ADDENDUM 1

PROJECT: 01-19-002 Replacement of Data Systems UPS Bid - Addendum 1
REVISED BID / TIME DUE: January 25, 2019 @ 2:00 p.m.

Dickson Center, Room 116

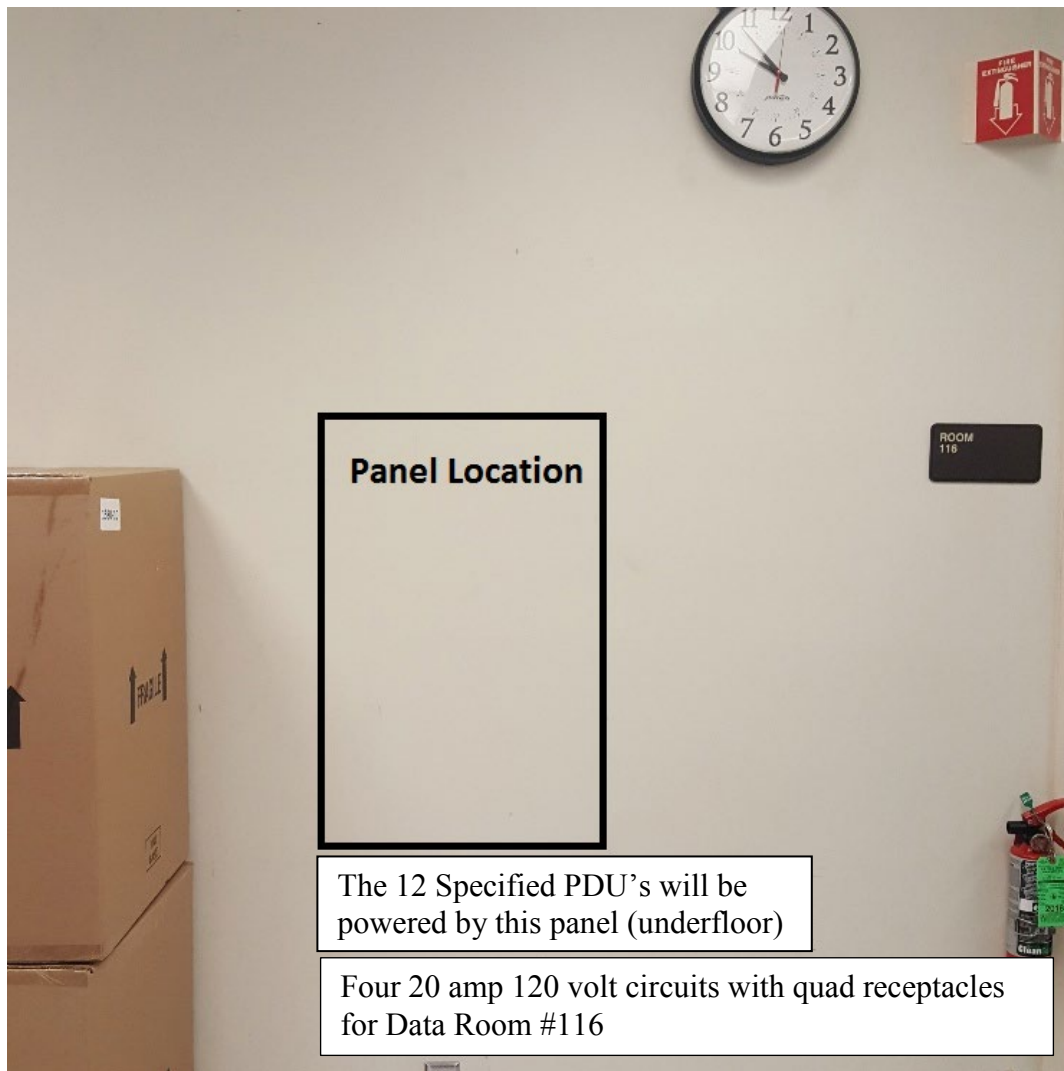
Output panel from new UPS to be mounted on the wall as noted below.

Circuit breaker distribution panel specification:

“B-side” UPS load distribution panel, a 175A main C/B, 208Y/120V 3ph-4w + Ground, 42-Spaces, wall-mount load distribution panel

Fifteen (15) 30A 2-pole

Nine (9) 20A 1-pole

One (1) 100A 3-pole

All remaining of the 42-spaces filled with 20 amp circuit breakers
